Request for Class II Permissive Change(C2PC)

FCC ID: VG8XM245AYY-PV5P

Date: 2023-12-04

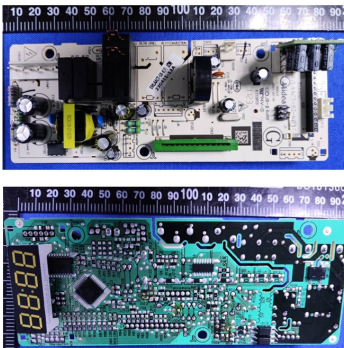
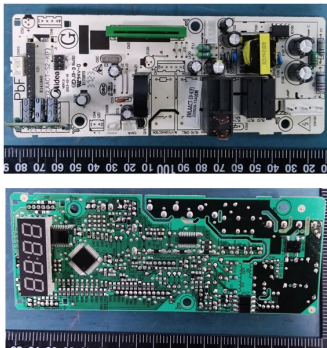
No.:	Original	New	Difference(s)
1			Keypad: Updated front keypad to accommodate child lock function (Child resistant oven door function)
2			Mother board: Modified the peripheral circuit (non-RF circuit) and some individual components and PCB layout. The magnetron and other circuit are exactly same as before
3	N/A		The new one adds a solenoid valve locking mechanism, the original is not.
